CITY PLANNING COMMISSION

- APPLICATION:**
- A. Variance to allow a new gas station, convenience market canopy and pump islands to be located in the required 50 foot setback
 - B. Variance to allow backout maneuvering and parking on a separate parcel

LOCATION: 5597 Stockton Boulevard

Staff has reviewed the applicant's revised site plan received November 19, 1986 and provides the following comments:

LAND USE & ZONING MAP

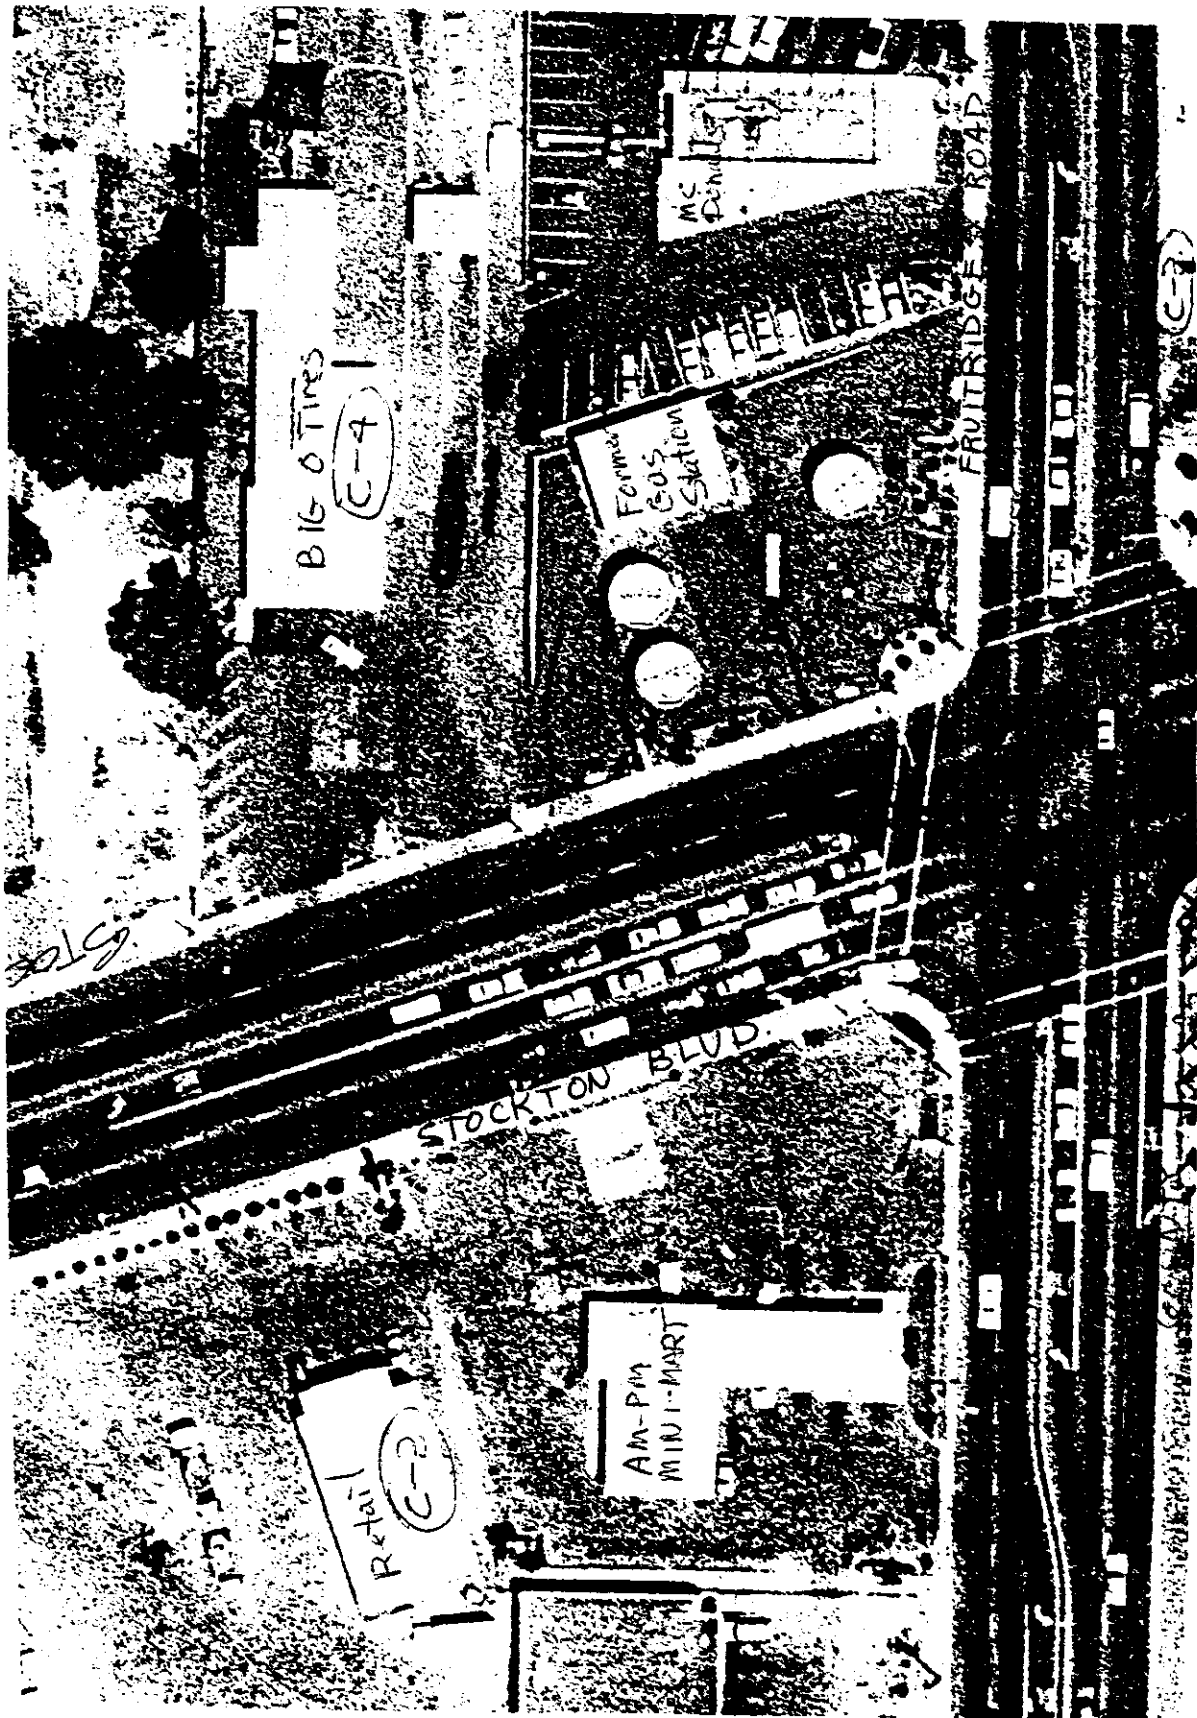
The former Mobile gas station had 3 detached circular canopies located within the 50 foot setback as indicated on the Land Use and Zoning Map in 1979. The proposed project consists of one canopy measuring 65 feet in length and 36 feet in width, straddling two pump islands. Overall height will be 16 1/2 feet.

SITE PLAN
SCALE 1" = 10'-0"

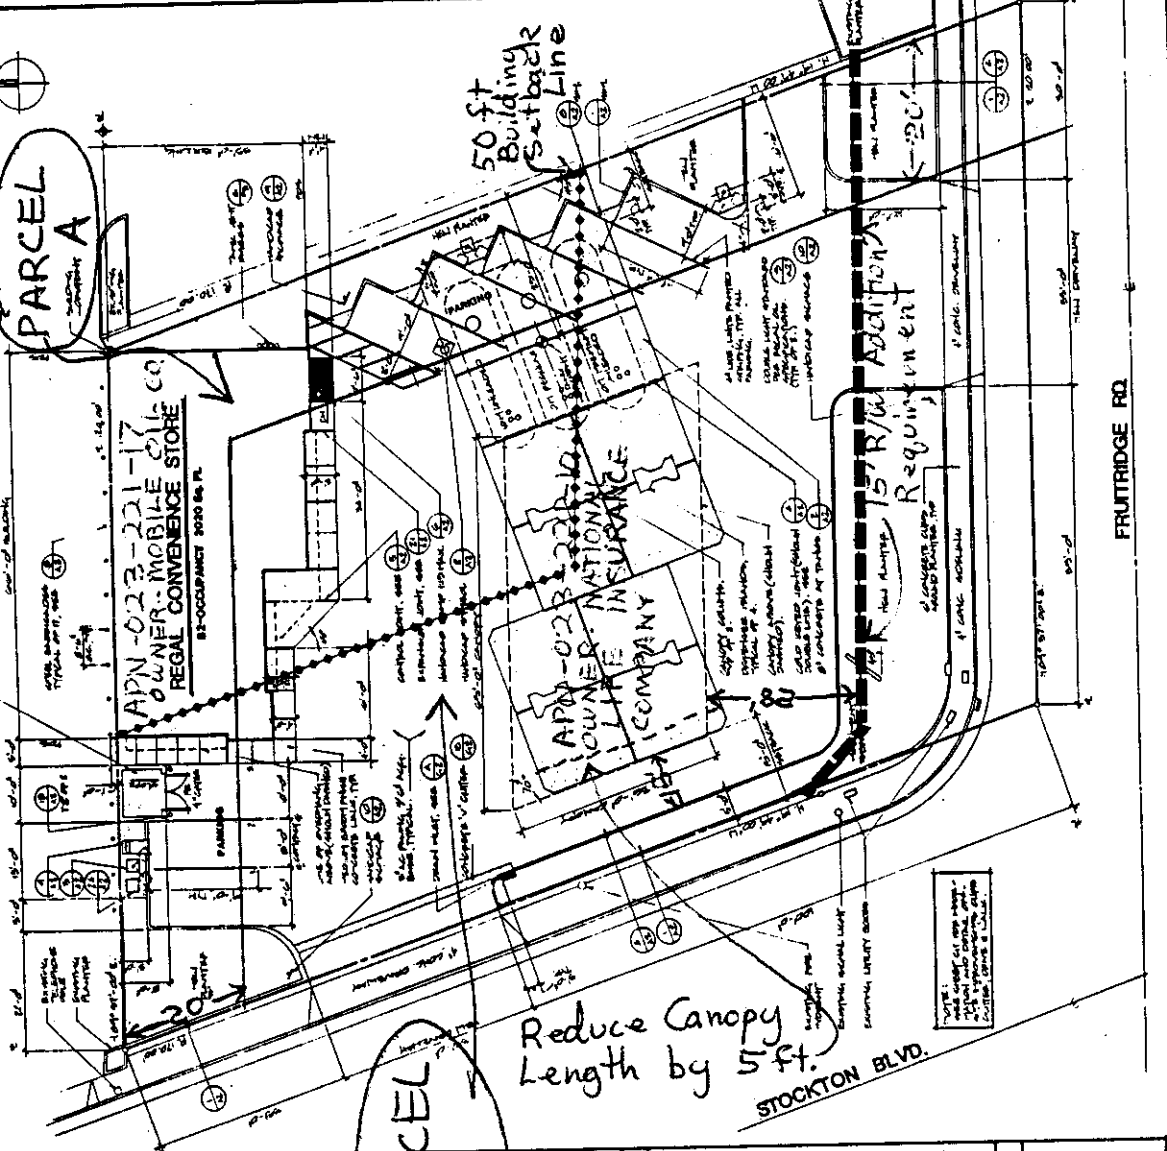
The City Traffic Engineer informed the applicant that an additional 15 feet of right-of-way will be required along the Fruitridge Road frontage for a future right-hand turn lane. The site plan shows a 20 foot wide landscape planter adjacent to the existing right-of-way. The City does not know when the additional right-of-way will be acquired. Staff supports the proposed 20 foot landscape setback for the present and finds the five foot landscape setback after right-of-way dedication acceptable due to the reduced area of the lot. Staff recommends that the landscape curb on the inside of the five foot landscape strip be constructed parallel to the new right-of-way and include a 20 foot radius at the corner of Stockton Boulevard and Fruitridge Road.

Staff notes that the canopy setback from Fruitridge Road's future right-of-way will be 28 feet. The former Mobile gas pump canopy was approximately 12 feet from the future right-of-way. Staff supports the setback off Fruitridge Road due to its increase from the previous canopy setback. The proposed canopy setback off Stockton Boulevard is 15 feet. The former canopy was setback 20 feet from Stockton Boulevard. Staff recommends that the length of the canopy be reduced by 5 feet to 60 feet so that a 20 foot setback would be established from the Stockton Boulevard right-of-way to edge of canopy. This would be consistent with setbacks of the previous Mobile gas pump canopy.

The proposed Mini-mart will encroach approximately ten feet into the 50 foot building setback area. The actual portion of the building contains approximately 150 square feet of the 2,020 square foot building that protrudes into the setback area. Staff supports the variance to allow this structure in the setback area due to the 120 degree property line angle at the northeast corner of the site. Unless the building is skewed to fit as a parallelogram or the building reduced in area, the 2,020 square foot structure could not fit on the site.

The proposed parking plan shows six regular spaces; one handicapped and a trash enclosure. A driveway is shown connecting the MacDonalds' restaurant to the east of the site. Staff recommends that the driveway be eliminated and that two more spaces be provided to bring the parking up to eight regular spaces. Parking is not counted in front of trash enclosures nor the handicapped space. A total of eight spaces are required for a 2,020 square foot building at a ratio of one space per 250 square feet. A revised site plan showing additional parking shall be submitted for review and approval by the Planning Director prior to issuance of building permits.

The applicant proposes relocating and eliminating driveways on Fruitridge. Staff supports the proposed location and design.

The applicant shows general landscaping areas. Staff recommends the applicant submit detailed landscaping and irrigation plans for review and approval by the Planning Director. Staff recommends that living ground cover, shrubs and bushes be used along the public right-of-way. Ground cover, 15 gallon trees and shrubs are recommended along the east property line. All parking will be required to meet the 50 percent shading requirement.

1. The applicant shall submit a revised site plan, indicating the location of eight on-site parking spaces, for review and approval by the Planning Director prior to the issuance of any building permits. Site plan shall also indicate two parcel lines, additional Fruitridge right-of-way and canopy redesign;

4. The canopy shall be reduced in width from 65 feet to 60 feet so that a minimum 20 foot setback is established to edge of canopy from the Stockton Boulevard right-of-way.

SIGNAGE

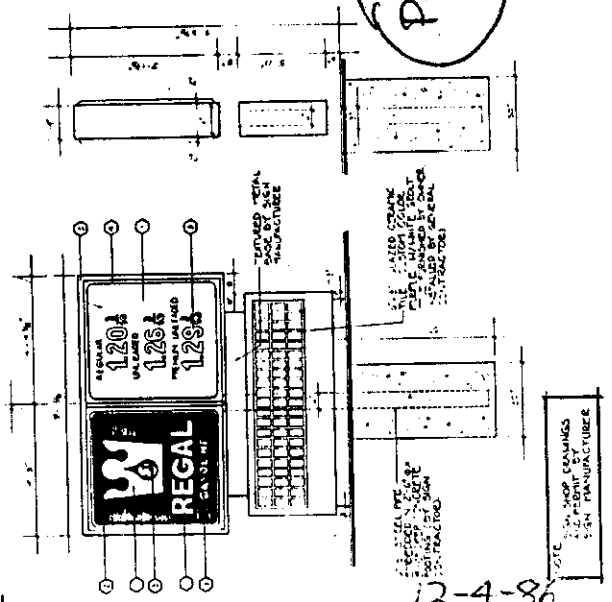
Internally illuminated, canned, plastic signs are proposed to be attached to the mini-market walls. A monument sign/price sign is proposed at the corner. Facia signs are proposed on the canopy. Staff supports the proposed monument sign, but has concerns over the possible duplication of price signs. Staff recommends that a sign program be submitted for review and approval by the Planning Director prior to issuance of sign permits, since the signs will be located on structures located within the 50 foot setback area.

5. The applicant shall prepare a sign program for all signs for review and approval by the Planning Director prior to issuance of sign permits. A monument sign is preferred with limited numbers of price signs attached to the canopy or detached on the site.
